## IDAP REPORT

<b>Property:</b>	7 Oxford Road STRATHFIELD DA 2020/193
<b>Proposal:</b>	Alterations and additions to a new dwelling approved as a complying development.
<b>Applicant:</b>	E Chowdhury
<b>Owner:</b>	W & V Manisier
<b>Date of lodgement:</b>	27 October 2020
<b>Notification period:</b>	9 November 2020 to 23 November 2020
<b>Submissions received:</b>	Nil
<b>Assessment officer:</b>	D Strbac
<b>Estimated cost of works:</b>	\$20,000.00
<b>Zoning:</b>	R2-Low Density Residential - SLEP 2012
<b>Heritage:</b>	No
<b>Flood affected:</b>	Yes
<b>Is a Clause 4.6 Variation Proposed:</b>	Yes, FSR (0.56:1) 2.5%
<b>RECOMMENDATION OF OFFICER:</b>	<b>Part approval</b>

*Figure 2: First floor plan with proposed alterations and additions highlighted in red.*

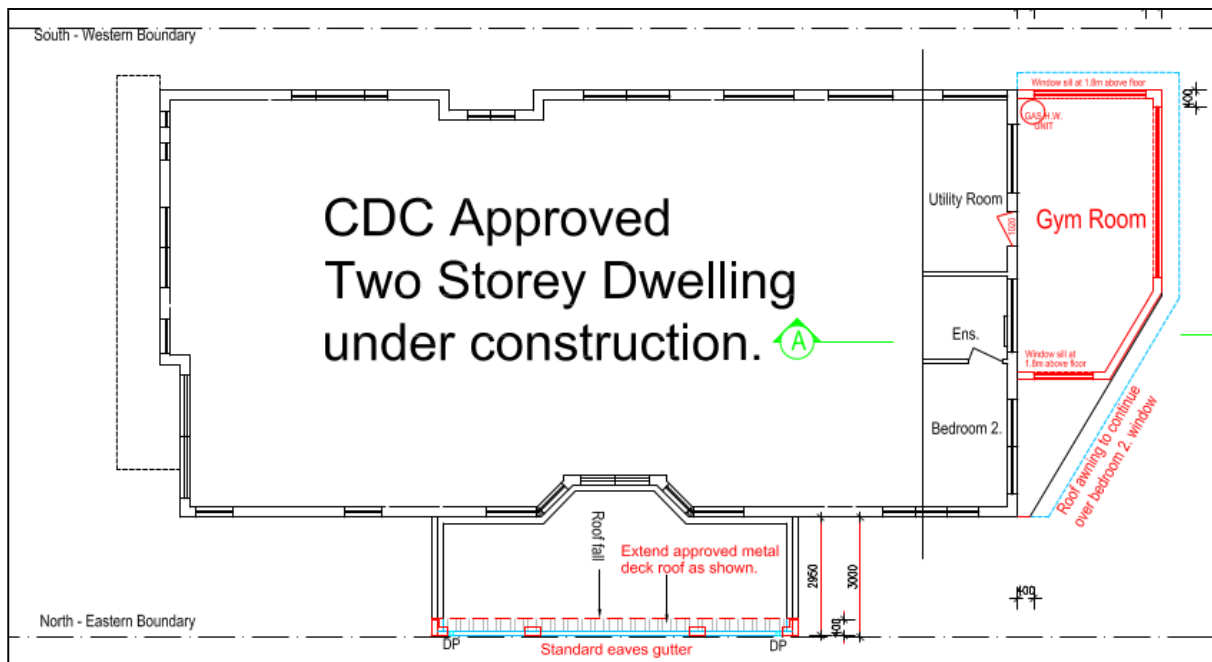
**Comments:** The proposed first floor addition exceeds the FSR allowance under Part 4.4 of the SLEP 2012. During the assessment process the applicant had initially proposed an extension to the CDC approved rear balcony however this was not supported due to the adverse privacy amenity impacts that would result from its excessive size (Figure 4). The applicant submitted revised plans which replaced the enlarged rear balcony with an enclosed gym room (Figure 5). Accordingly, this room has been included in the FSR calculation and contributes to an exceedance of the allowable GFA.

Regardless of the applicant's failure to provide a written request as per Clause 4.6, Council is unable to support the proposed variation of (0.56:1) 2.5% to the maximum FSR provision under Clause 4.4C of SLEP 2012 given that:

- There are no substantive merits and justification for the excess FSR;
- There are no site constraints and contextual considerations that would warrant a contravention to the development standard;
- The contravention to the development standard creates an incompatible built form that is excessive in bulk and scale and represents an overdevelopment of the site;
- The proposal fails to achieve a high quality urban form;
- The proposal fails to promote a spatially appropriate use of land;
- The proposal fails to achieve key objectives under Clause 4.4;
- The proposal is not in the public interest as it will introduce an excessively massed and bulky built form in the surrounding locality that will have adverse impacts and will set an undesirable precedence.

In light of the above, the proposed contravention is unreasonable and unacceptable and therefore, is not supported. In the event of approval, a condition will therefore be included in the consent which states that the first floor addition does not form part of the development approval.

Amendments made in red on approved plans	All changes made in red on the approved plans shall be updated and shown on the Construction Certificate plans.
Deletion of gym room	The gym room does not form part of this approval and is to be removed/deleted.
Carport side setback	The carport is to be setback 0.5m from the north-eastern side boundary.

Figure 6: Carport height at each side

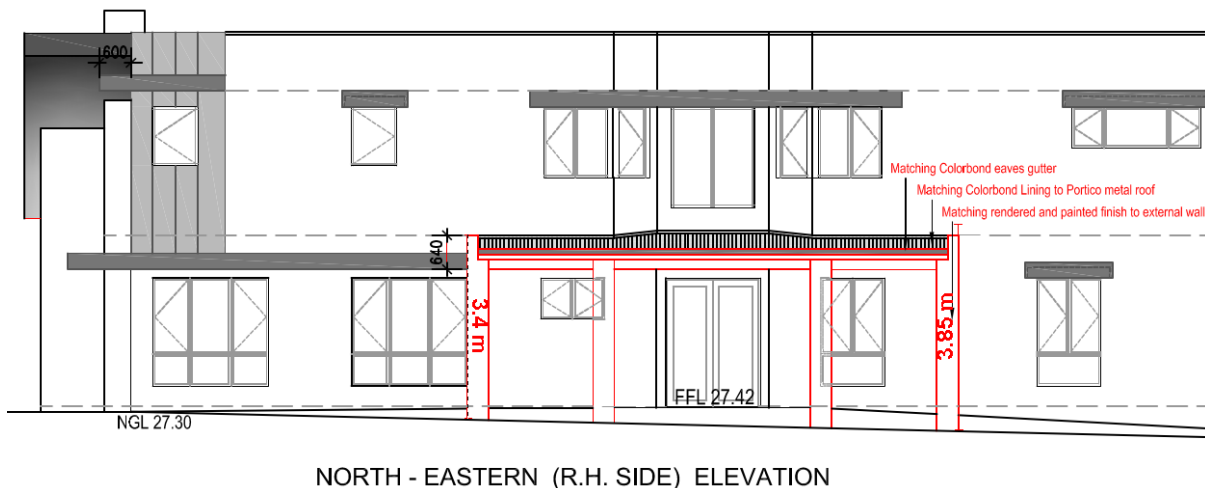
Whilst the proposed carport structure exceeds the maximum height requirement of 3.5m, it is noted that, given the slope of the site, the proposed height ranges from 3.45m at the front of the carport, to 3.85m at the rear of the carport (Figure 6). The non-compliance is therefore limited to the rear portion of the carport. The carport has also been largely recessed, more than 7m from the front building line of the dwelling, and is unlikely to visually dominate the appearance of the dwelling from the street. The proposed carport is considered to be proportionate to the dwelling and the non-compliant height is considered to be minor and acceptable in the circumstances.
